CHANGE ORDER REQUEST

PROJECT NAME: Barth Athletics Complex
HMS Phase IIIA

SCMC C.O.R. #: 6
DATE: 5/8/2019

DESCRIPTION: SUPPLY & INSTALL 45 ELBOW FITTINGS TO BRING AC-4A; 4B VERTICAL SUPPLY DUCT RISERS AS PER RFI # 06

SK-01-08-09-2018-1819

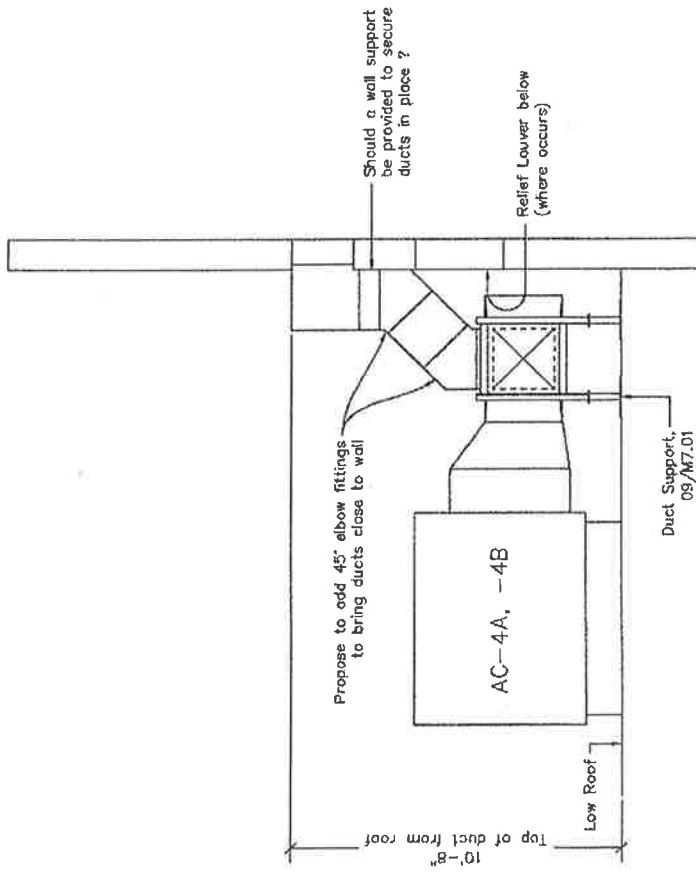
Building section view 1/A3.11 shows 88x20 (L) supply ducts rising up vertically from 24x24 (L) ducts before turning to penetrate new block wall at C-line into gymnasium.

We have been unable to locate a detail showing how these vertical duct risers are supported.

Please review contractor sketch SK-01-08-09-2018-1819 and advise if wall supports are needed.

Should a wall support
be provided to secure
ducts in place?

Propose to add 45° elbow fittings
to bring ducts close to wall

Adding 45's to bring duct close to wall is acceptable. Please see attached sketch (page 5) detailing how the 90x30 duct shall be supported by the exterior wall.

A3.11

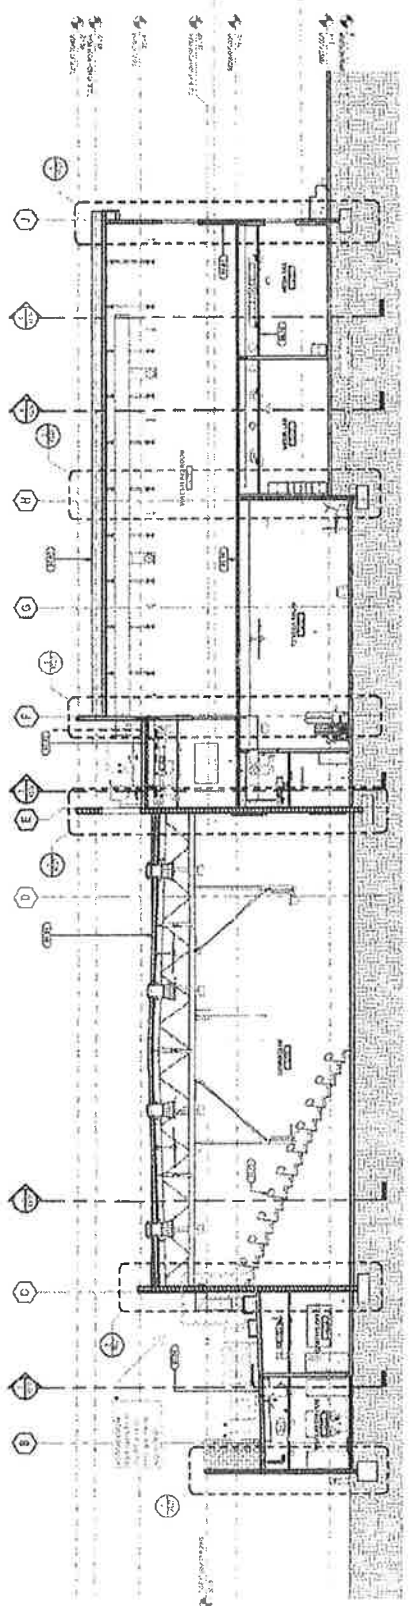
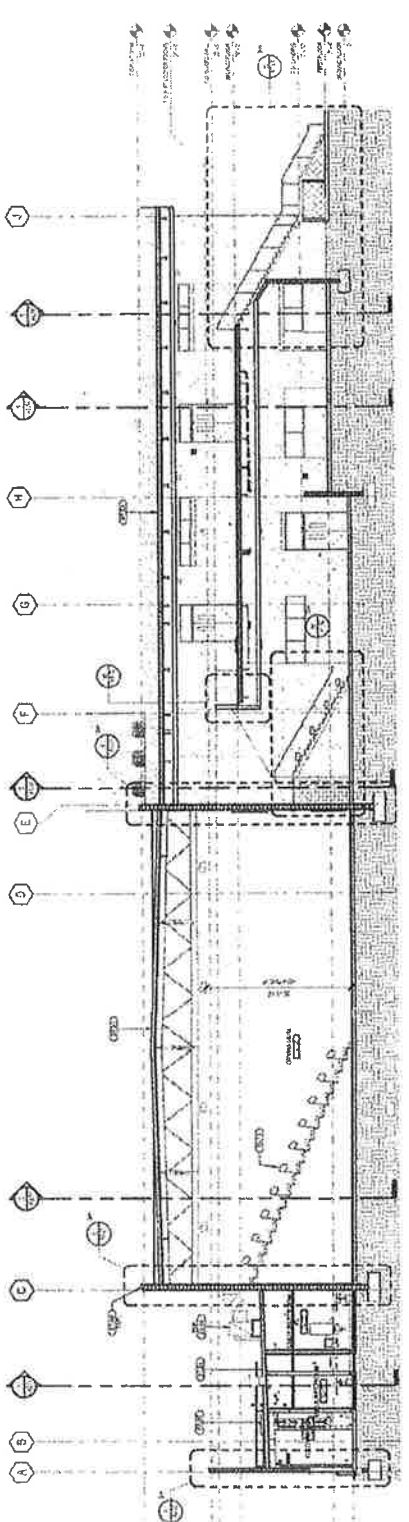
4b. Response: Air foil vane and vane rail are installed in new 45 elbow fittings not shown on original drawings. See detail 1/A3.11 which shows new ducts rising up vertically away from wall. New 45 deg. elbow fittings were provided to bring ducts close to wall to be secured in place with exterior wall support. Refer to RFI 6 and associated sketch SK-01-08-09-2018-1819.

5b. Response: Contractor must follow DSA approved details at time for bid not SMACNA standards. There was no detail provided for support of new supply ductwork rising up vertically along CMU wall before penetrating wall into gymnasium at C/L C. Contractor should be compensated for additional work not shown on plans at time for bid.

FIG. B - SUGGESTED SIZING

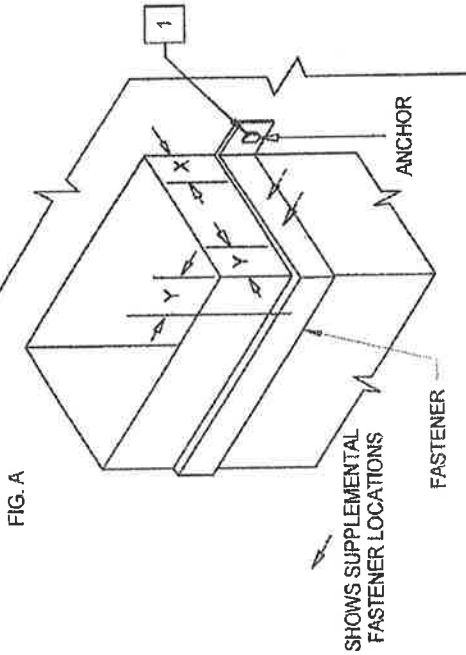
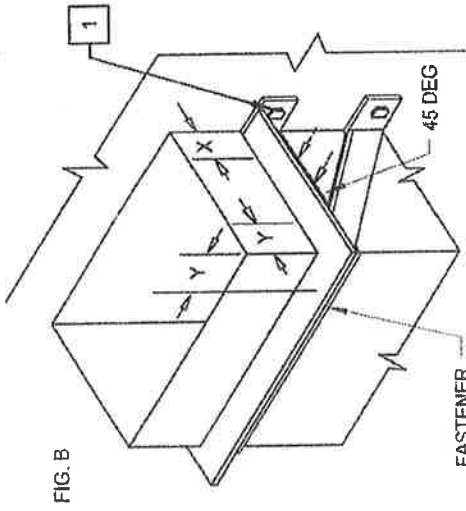
Per RFI No.: 06 response contractor should furnish and install 45 elbow fittings to bring AC-4A, 4B vertical supply duct risers close to wall and support with ductwork wall support detail 17 figure B

5a. Review Comment: The wall support detail is based on SMACNA standards which are referenced on our drawings and industry standard there should be no cost associated to this clarification.
